**DEFENSE NUCLEAR FACILITIES
SAFETY BOARD**

July 26, 2022

Staff Report

Savannah River Site 296-H Tritium Stack Structural Review

Figure 2. *Example Cross-sections for Vertical and Horizontal (“confining”) Reinforcement*
(a) *Single Layer of Reinforcement* (b) *Two Layers of Reinforcement (“two face”)*
[Note: These are not cross-sections of the 296-H stack]

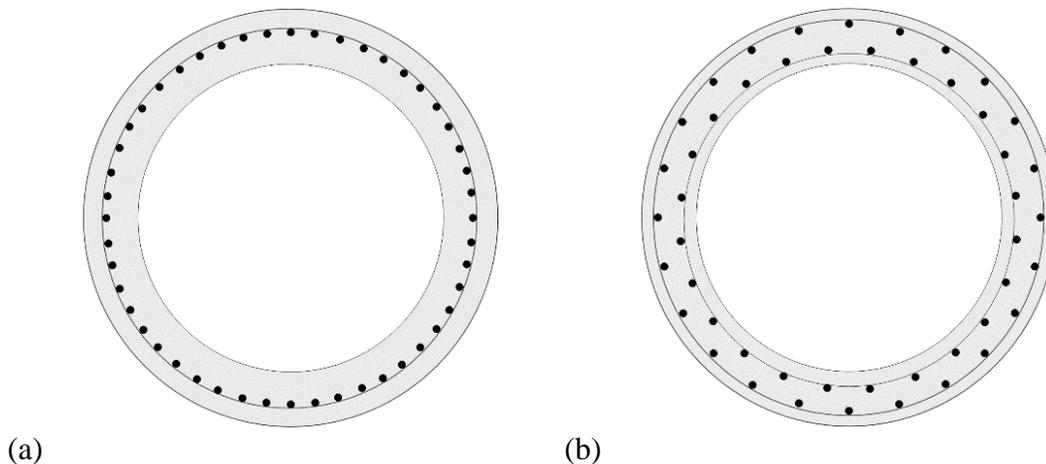
Single Reinforcement Design—Due to the vintage of the 296-H stack, it was designed with dated practices. In particular, the stack only contains one layer of vertical reinforcing steel along its length and only one layer of circumferential (confining) reinforcing steel in the horizontal direction. Figure 2 compares a single reinforcement configuration with a two-layer (“two-face”) reinforcement configuration. American Concrete Institute Standard 307-08, *Code Requirements for Reinforced Concrete Chimneys* [10], states the following in its commentary Section R4.1 (emphasis added):

Since SRNS does not inspect the interior of the 296-H stack, the presence of vertical cracks within the stack has not been determined. It is SRNS’s position that there are likely no

interior vertical cracks since they would propagate through the thickness of the stack and be seen on the exterior of the stack. However, the Board's staff notes that interior vertical cracks may not manifest themselves on the exterior of the stack due to the presence of confining steel surrounding the vertical reinforcement.
